Subject: Collin County Healthcare Facility, Parking Garage, and Medical Examiners  
PCO No. 064; RFI #234 ME Partition Type Clarification

**Issue No. 064 - RFI#234 ME Partition Type Clarification      Amount**

# Change Order

MWL Response : X-Ray 140:

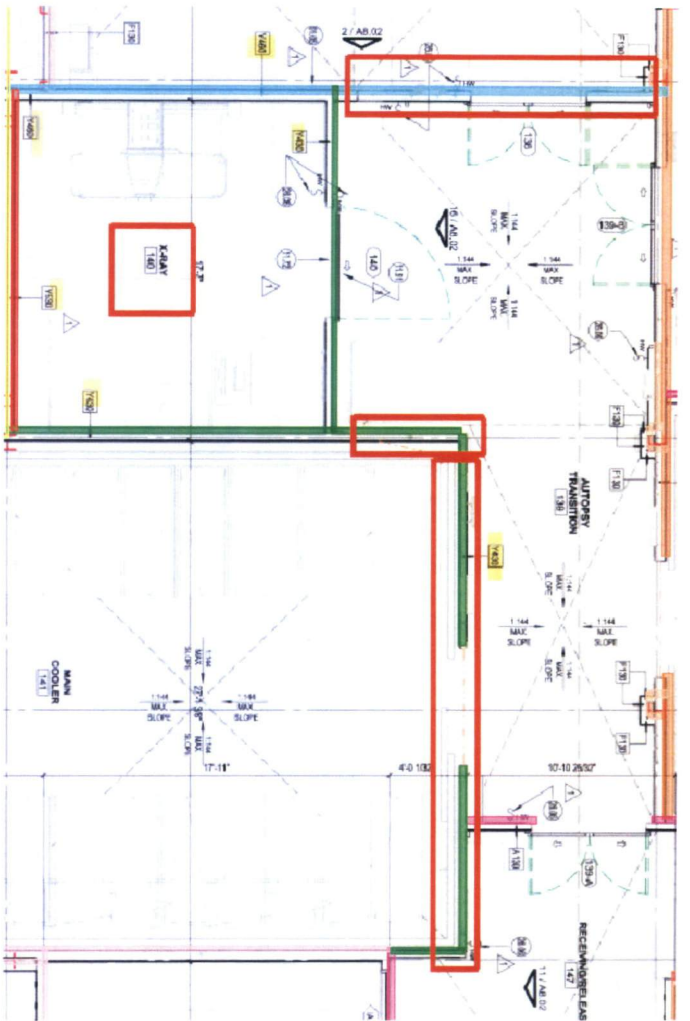
- Please clarify whether the lead-lined drywall walls need to be extended into the adjacent non-X-ray rooms?

The lead lined walls only need to be in the envelope of the X-ray room (4 walls and door). Refer to image.

MWL Response : Property Room 144:

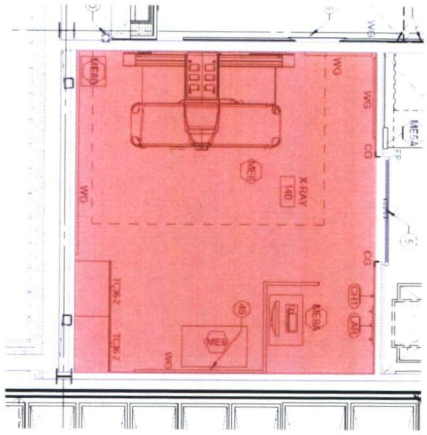
- In Room #144, all walls are specified to include security mesh, with the exception of one wall that calls for lead-lined drywall. Could you please confirm if this information is accurate? Additionally, should the intent noted as Y430 be revised to Y130?

Only the 4 walls around this room get the wire mesh. There should not be any lead-lined walls in this area. The only room with lead lined walls is noted above in X-ray  
Refer to image
